**HORIZONTAL DIRECTIONAL DRILL ANALYSIS
I-81 ROAD CROSSING
PADEP SECTION 105 PERMIT NO.: E21-449
PA-CU-0136.0003-RD-16
(SPLP HDD No. S2-0220-16)**

This reanalysis of the horizontal directional drill (HDD) installation of a 16-inch diameter pipeline that traverses Interstate Highway 81 (I-81), Middlesex Road, Wetland W-I30, and Stream S-I47 in Middlesex Township, Cumberland County, Pennsylvania, is in accordance with the Stipulated Order issued under Environmental Hearing Board Docket No. 2017-009-L for HDDs listed on Exhibit 3 of the Stipulated Order. This HDD is number 9 on the list of HDDs included on Exhibit 3 of the Order.

REVISED HORIZONTAL DIRECTIONAL DRILL DESIGN SUMMARY: 16-INCH

Figure 2. Redesigned 16-Inch HDD Plan and Profile

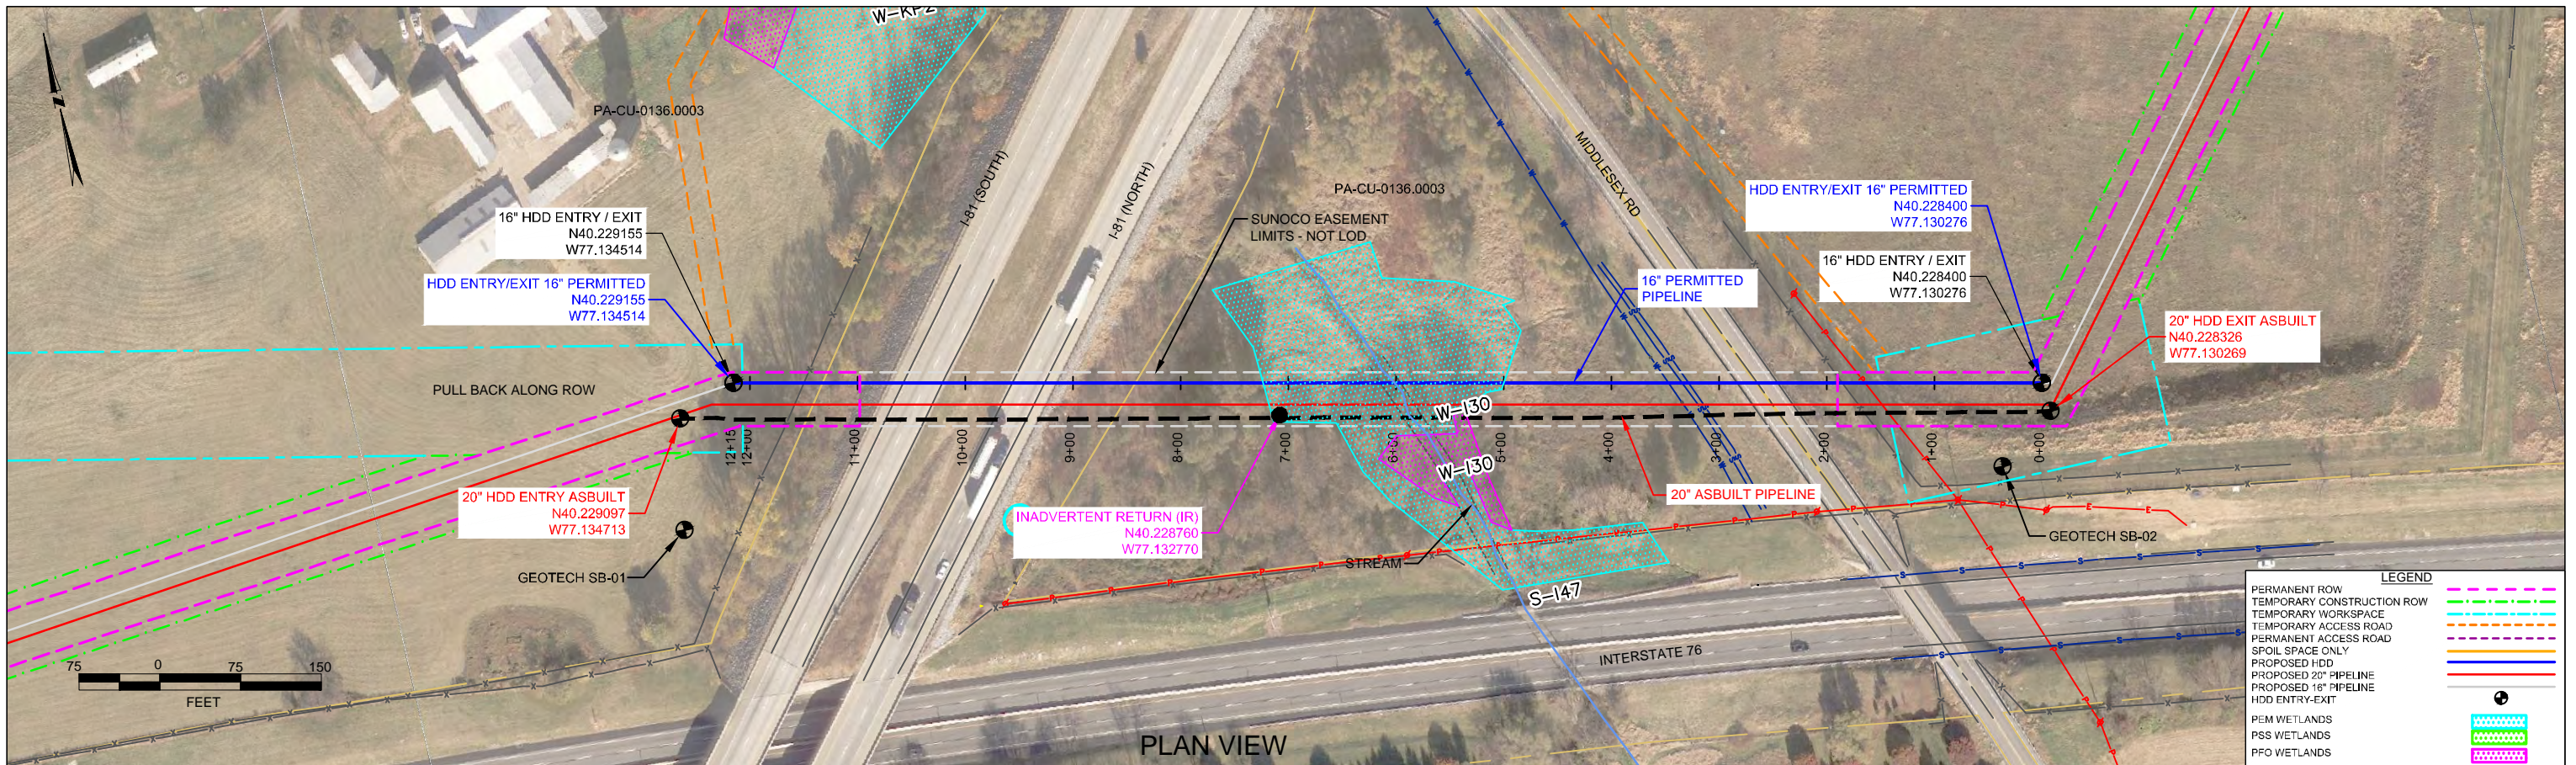
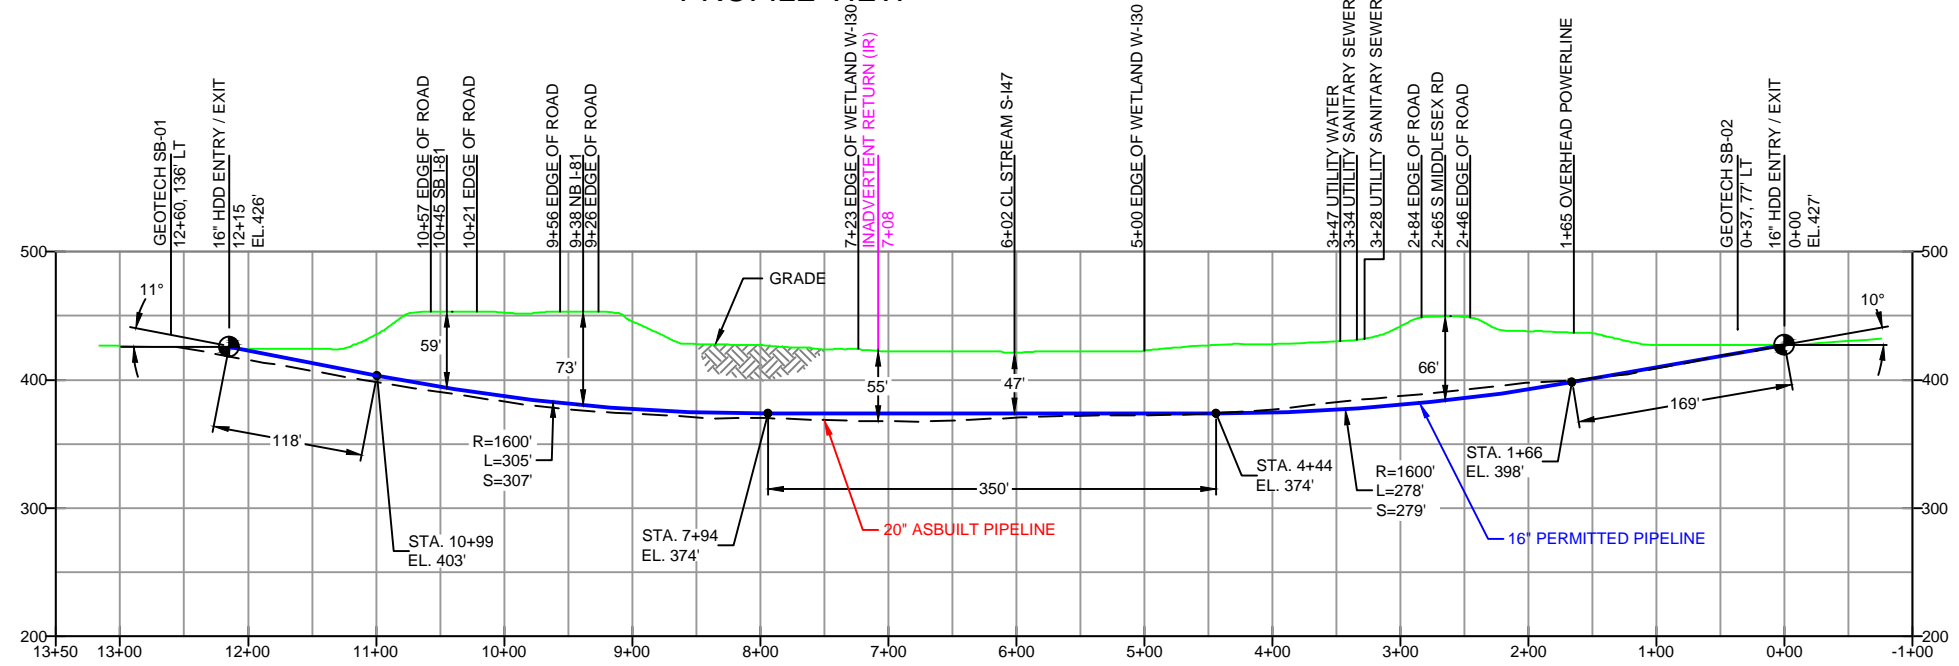
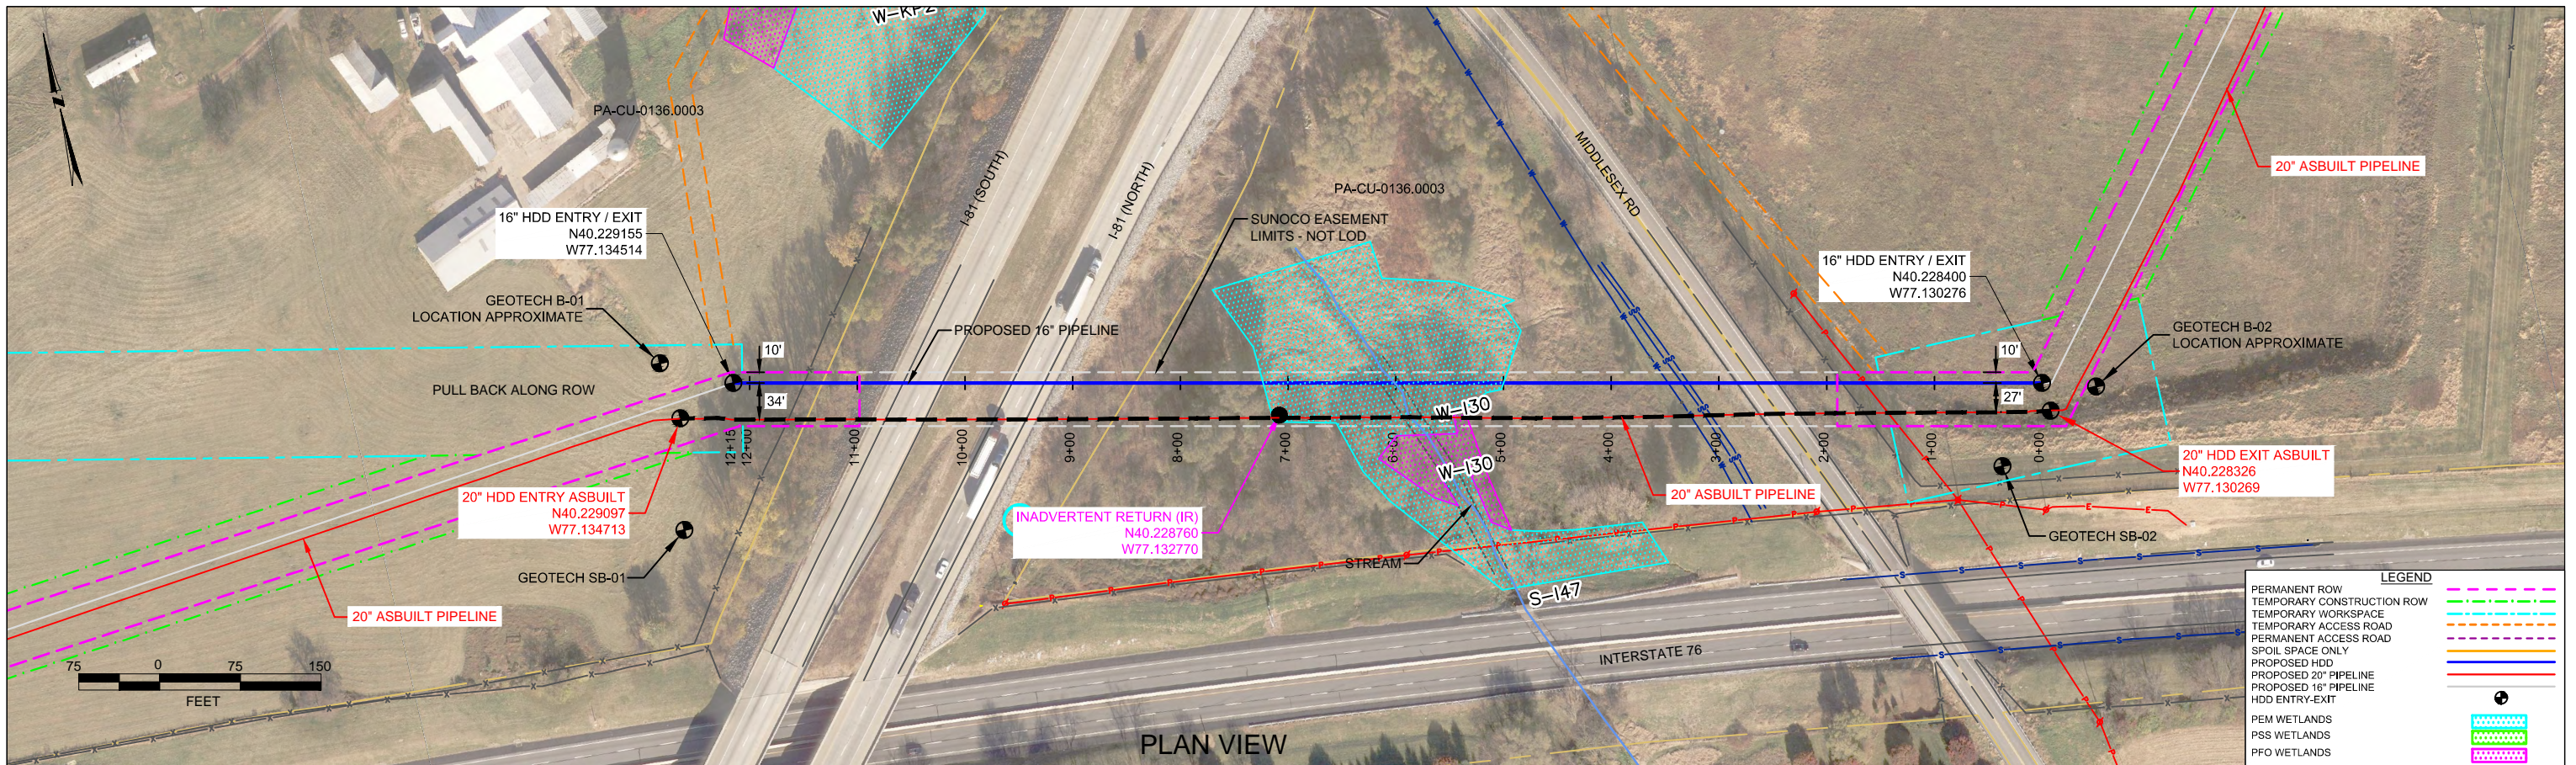
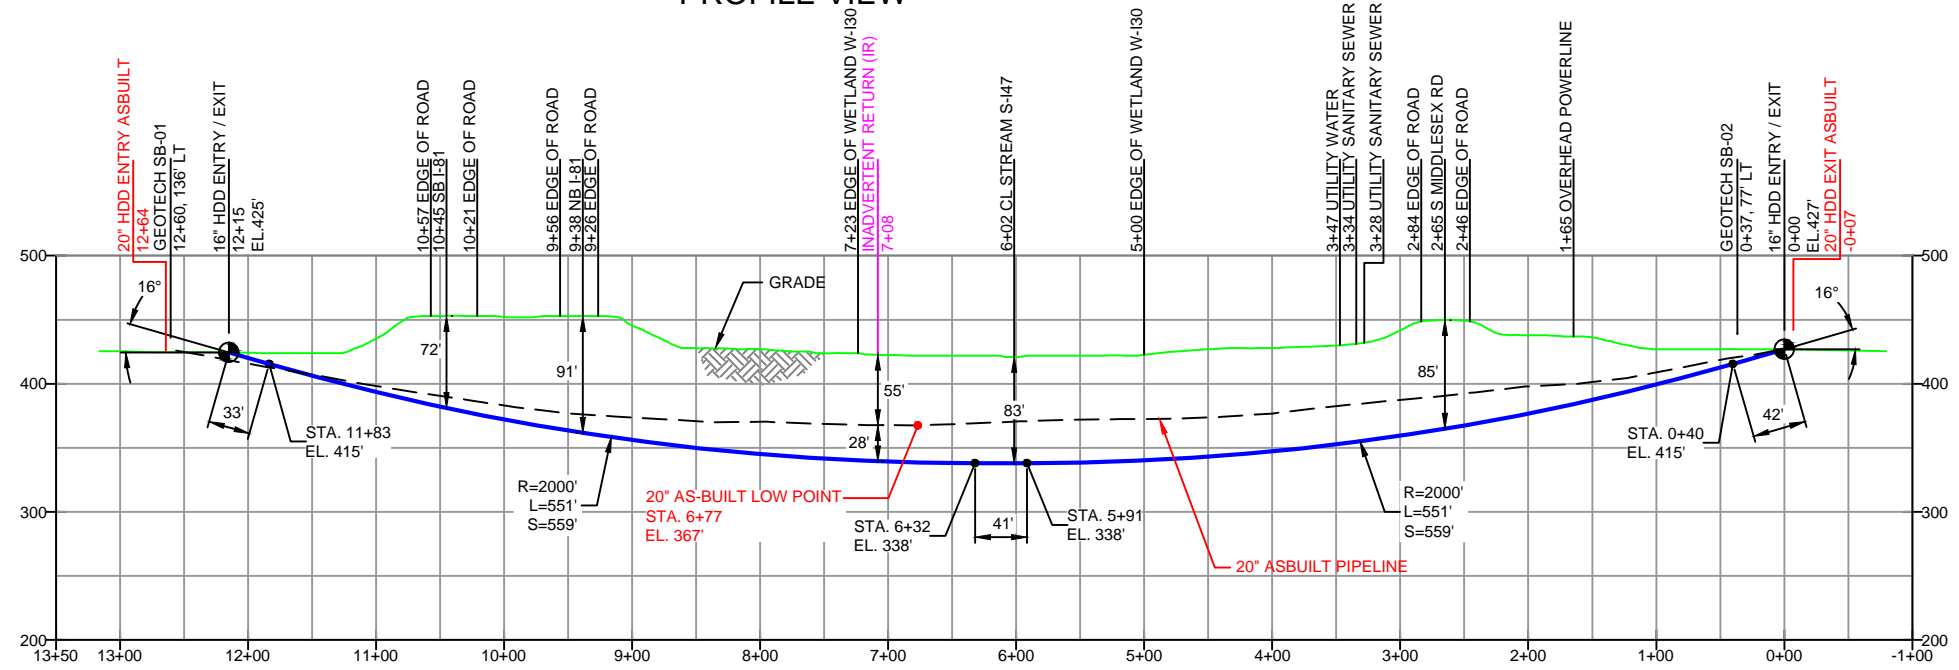
Additional geologic investigation has been completed, and the “as built” record for the 20-inch pipeline has been utilized in the redesign of the planned 16-inch HDD. The redesign adjusts the HDD profile deeper into bedrock and increases the angles of to minimize the time required to enter into and exit out of bedrock. A summary of the redesign factors is provided below. The original and redesigned 16-inch HDD plan and profile drawings are provided in Attachment 2.

- Horizontal length: 1,215 feet (ft)
- Entry/Exit angle: 16 degrees
- Maximum depth of cover: 93 ft
- Depth below wetlands: 87-90 ft
- Depth below stream: 83 ft
- Pipe design radius: 2,000 ft

As shown on Figure 2 in Attachment 2, the redesigned HDD profile for the 16-inch pipeline increases the depth of cover, and exit/entry angles. The redesign of the HDD will not prevent all IRs. IR's are common on entry and exit of the drilling tool and other measures are required to minimize IR potential. In particular, upon the start of this HDD, SPLP will employ the following HDD best management practices:
